Project	IEEE 802.16 Broadband Wireless Access Working Group <http://ieee802.org/16>	
Title	Adaptive bit loading for vertically encoded MIMO	
Date Submitted	2005-03-09	
Source(s)	Qinghua Li, Xintian Eddie Lin, Alexei Davydov, Ada Poon, Nageen Himayat, Minnie Ho, Jose Puthenkulam Intel Corporation	qinghua.li@intel.com Voice: +1-408-765-9698
<hr/>		
Re:		
<hr/>		
Abstract		
Purpose	Adoption of proposed changes into P802.16e Crossed-out indicates deleted text, underlined blue indicates new text change to the Standard	
Notice	This document has been prepared to assist IEEE 802.16. It is offered as a basis for discussion and is not binding on the contributing individual(s) or organization(s). The material in this document is subject to change in form and content after further study. The contributor(s) reserve(s) the right to add, amend or withdraw material contained herein.	
Release	The contributor grants a free, irrevocable license to the IEEE to incorporate material contained in this contribution, and any modifications thereof, in the creation of an IEEE Standards publication; to copyright in the IEEE's name any IEEE Standards publication even though it may include portions of this cont

Figure 254a Adaptive bit loading for vertically encoded MIMO with CTC in optional zones.

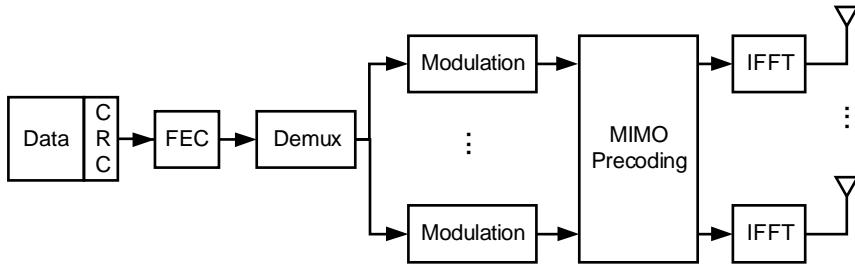
Added section 8.4.8.10 at line 27 on page 442 of [1] as follows

Figure 254a and 254b illustrate transmitters of vertically encoded MIMO with adaptive bit loading for CTC and CC respectively, where there are L layers in each transmitter. The FEC encoder generates coded blocks for the layers sequentially. The code bits of each block are distributed into L layers by the demultiplexer. The demultiplexer extracts bits for the layer with a higher modulation level before those with lower modulation levels. Denote the number of bits per

subcarrier on the j -th stream as Q_j . For the extraction for the l -th layer, the i -th extracted bit is the k -th bit in the remaining bits, where $k = \text{round}(i d_l)$ and $d_l = \frac{1}{Q_l} \sum_{j=l}^L Q_j$.
